Committee: Cabinet Member Report

Date: 13th October 2015

Subject: Proposed VSW CPZ (Chester Road Area, Wimbledon Village – formal consultation

Drawing No.
Z78-224-02

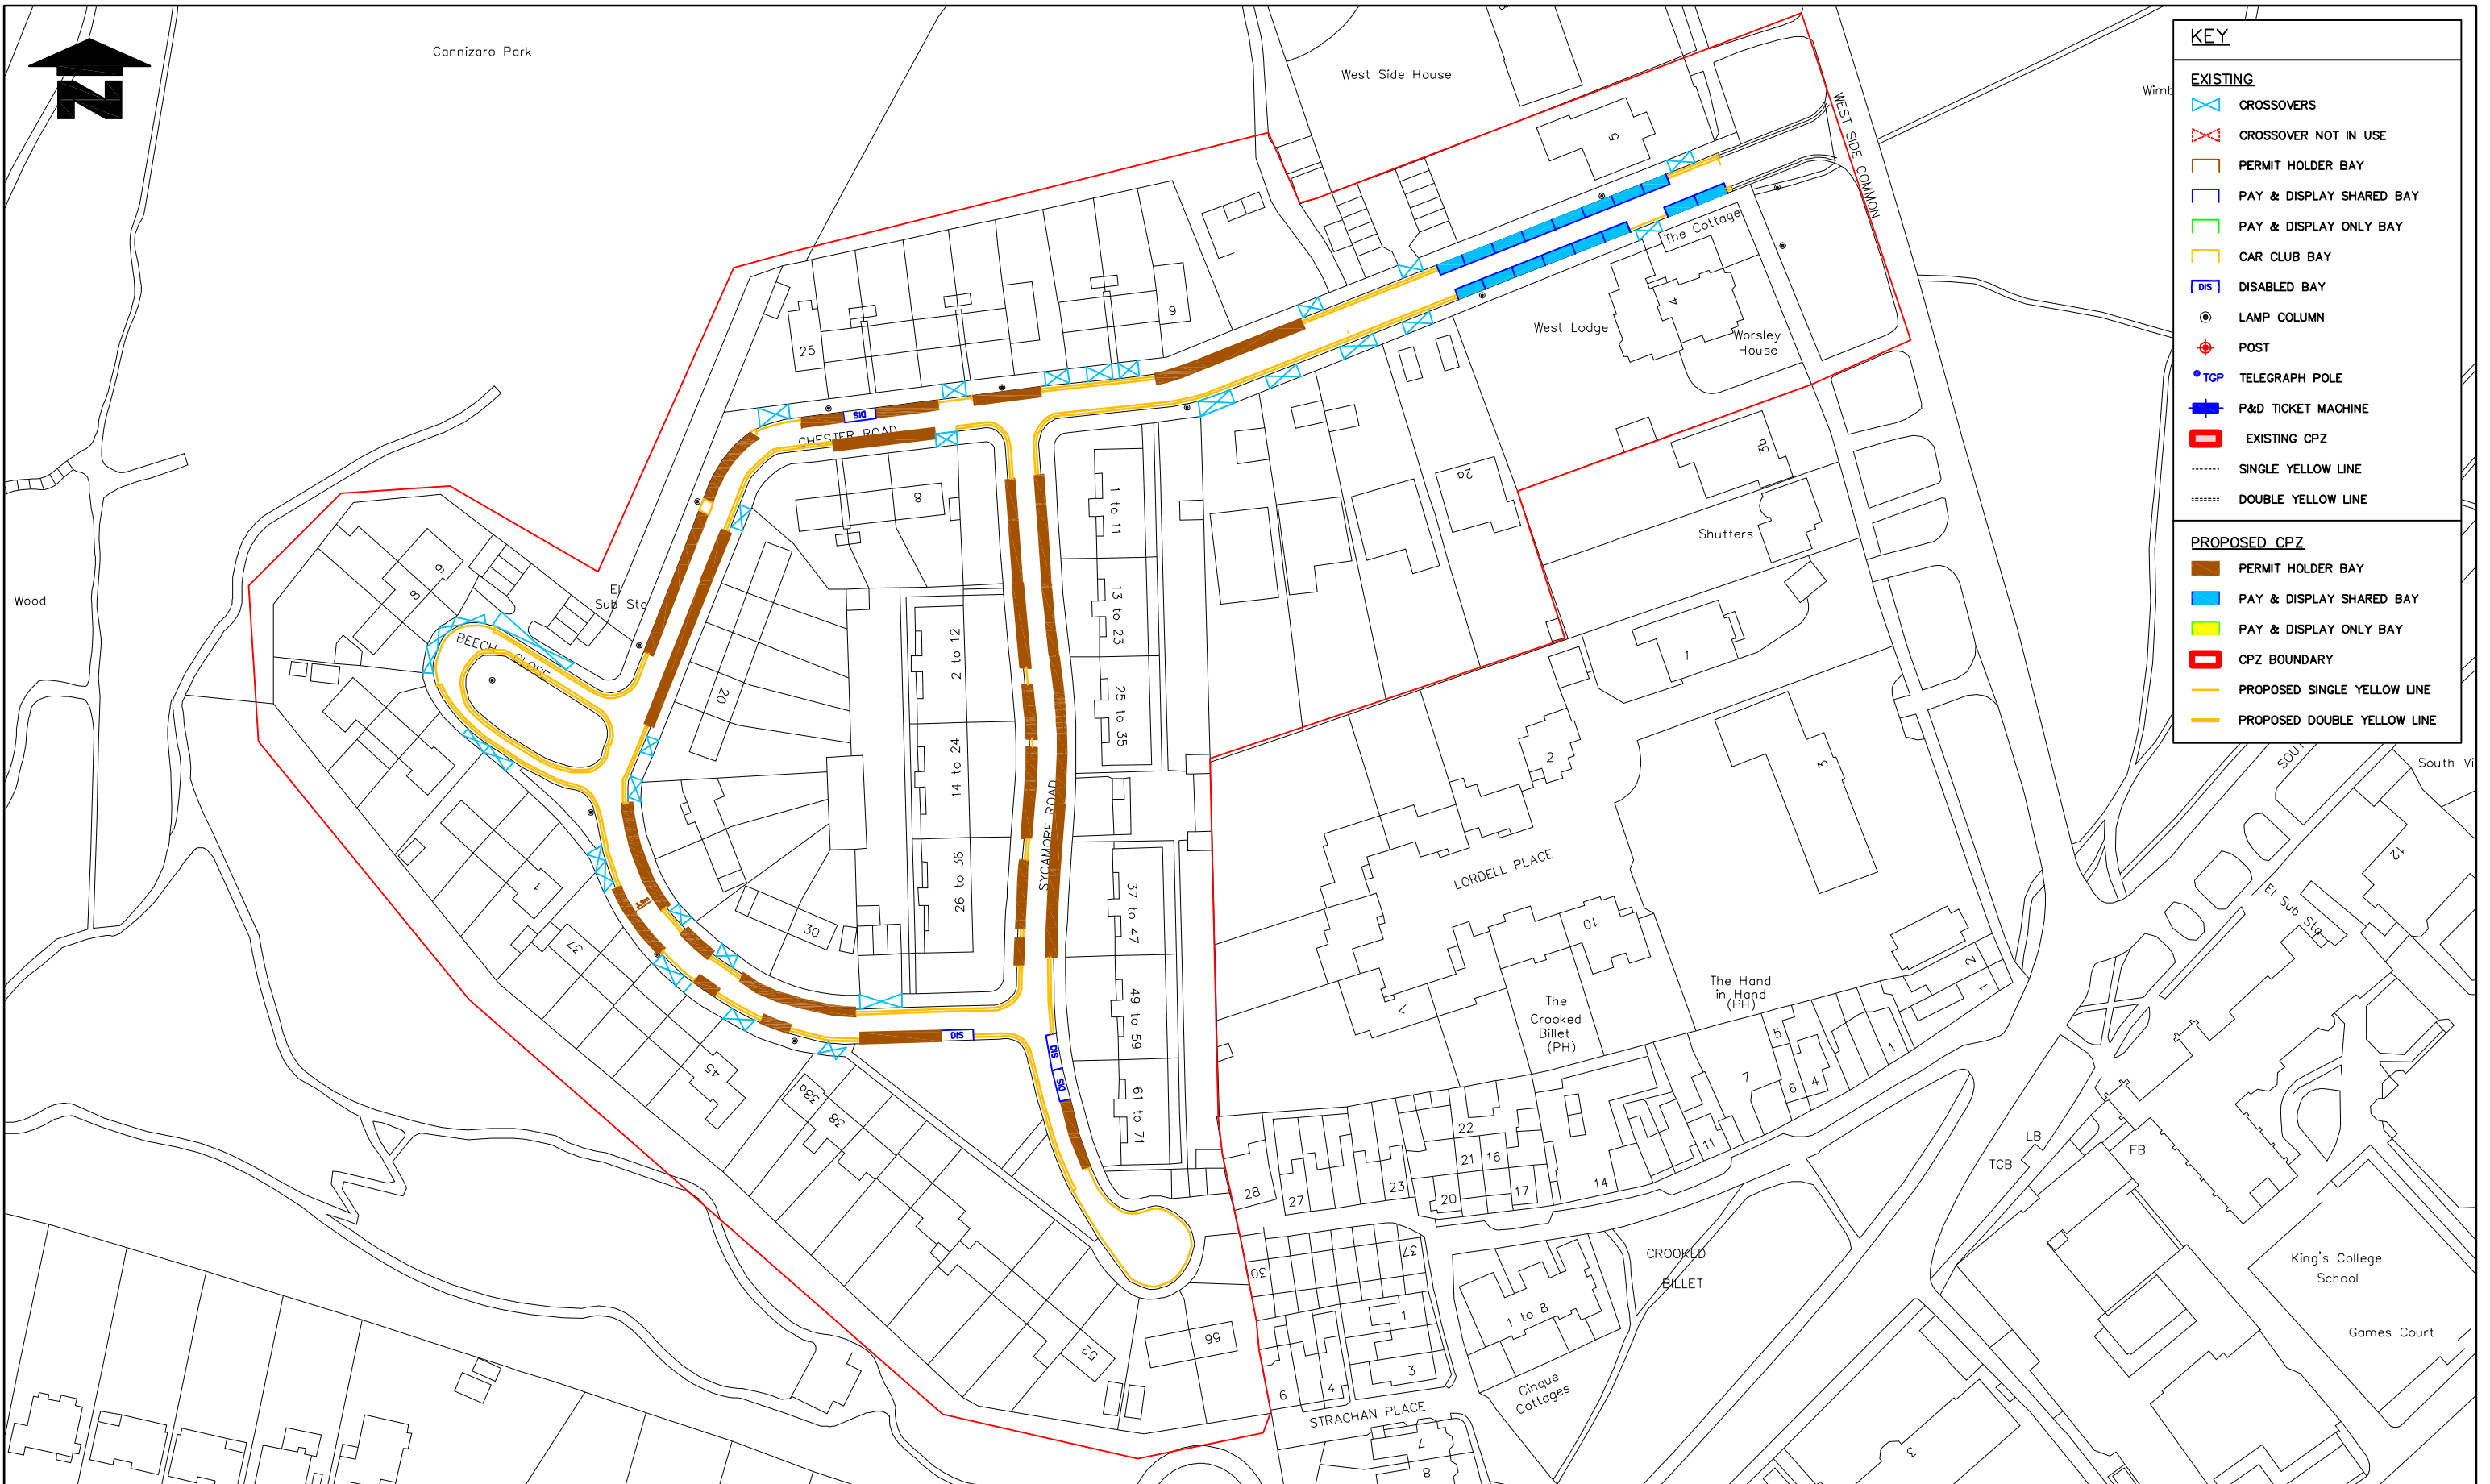
The dropped curb pavement crossovers have worked successfully thus far with white lines and should continue to remain so. Your proposal to put double yellow lines on most of the pavement crossovers seems arbitrary and not necessary. Emergency services have not in the past had any serious problem.

2. The dropped curb pavement crossovers have worked successfully thus far with white lines and should continue to remain so. Your proposal to put double yellow lines on most of the pavement crossovers seems arbitrary and not necessary. Emergency services have not in the past had any serious problem.

3. On Chester Road and Beech Close, I do not see the need to include double yellow lines which means no parking at any time, so the people cannot have their evening guests park even across their driveway, which would be a perfectly normal thing to do and which is allowed at 8/9 Beech Close. They cannot even have deliveries.

4. In particular to make the North side of Beech Close double yellow lines seems unnecessary. These proposals mean that anybody in Beech Close that has weekend visitors cannot park their cars nearby and frankly for what reason? In this context I think that there should be pavement parking bays on the north side of Beech Close next to electricity sub- station/ garages. These are perfectly acceptable parking spaces. They have always been used as such and there is no compelling reason to stop that.

5. To summarise in my opinion the crossovers in Chester Road and Beech Close should all be white lines except in the entrance of Chester Road on the left side from the common to Sycamore Road, Those houses have sufficient drive space for their visitors and builders to park in their drives! Elsewhere there is no need for double lines.

The map as included by the council, does not show the dropped curbs at numbers 5 and 6 Beech Close. Also number 2 may well wish to include a dropped curb in the future. There is also a pole not shown outside number 4.

1) The cumulative effect of all these dropped curbs is that no one ever parks in the road, as they would be blocking the almost continuous run of driveways. In addition, the green in the center of the close has posts continuously around its edge so no one can park on it either. Large service trucks can therefore easily circumnavigate Beech Close and are not encumbered. There is thus no need whatsoever for double yellow lines.

3) People never ever park fully in the narrowest part of the road, so double yellow lines are completely unnecessary. Where the road is at its narrowest, cars only ever park half over the curb and usually only when no other parking is available. This does not impede traffic.

4) At the widest part of the Close opposite 7-9, there is facility next to the green for a car to park without impeding traffic. It is common practice for this spot to be used by others such as the dog walker who needs safe access for the dogs. Stopping there would become an offence if yellow lines were to be added and cause unnecessary difficulty.

- 1) There is very good off road parking on the north side of Beech Close to the right of the Garages entrance, near the substation and where the curb is mostly dropped. It is possible to fit 3 - 4 cars completely off the road, here. This parking facility appears to have been overlooked.

- 4.7 The minimum running width required by a fire engine to access residential road is between 3 and 3.5 metres. With cars parked fully on the carriageway, on one side of the road, the average available road width for access is reduced to 2.5 metres and even less in some sections of the road. Also the footway is too narrow to allow footway parking. When considering road safety, S.122 of the Road Traffic Regulation Act 1984 places a duty on the Council "to secure the expeditious, convenient and safe movement of vehicular and other traffic (including pedestrians)

In response to parking across dropped kerbs during the hours of operation, the Council does not actively promote crossover parking within a CPZ. If a crossover parking is introduced as part of a CPZ, during controlled hours any vehicle with a valid permit for that zone may park adjacent to a dropped kerb marked with a white access bar marking. The Council will not enforce obstruction in this instance, as the CPZ is in operation. The option of cross over parking was not included as part of RPC CPZ consultation.

It is the policy of the Council to improve the environment by making it safer for both motorists and pedestrians. One way this can be achieved is by regulating the number of parked vehicles in the area, particularly at key locations such as at junctions, narrow roads, cul de sacs and at bends. The aims of the proposed double yellow lines waiting restrictions are to improve visibility and to provide clear access for all road users, particularly vulnerable road users such as pedestrians, push chairs and wheelchair users who for example may wish to make proper use of the section of dropped kerb at junctions and the emergency services.
